TRANS/WP.29/GRRF/2004/20
7 July 2004

PROPOSAL FOR DRAFT AMENDMENT TO REGULATION No. 30

(Pneumatic tyres)

Transmitted by the expert from the United Kingdom

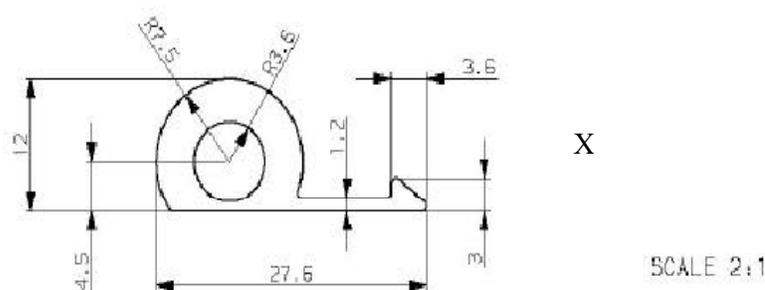
Insert a new paragraph 3.1.12., to read:

- "3.1.12. The symbol below if the tyre is a "run flat tyre", followed by "X" in km, where "X" equals the distance to which the tyre is approved [minimum 80 km/h] when tested in the "flat tyre" running mode. The height of "X" shall be a minimum of 12 mm.

All dimension are expressed in mm."
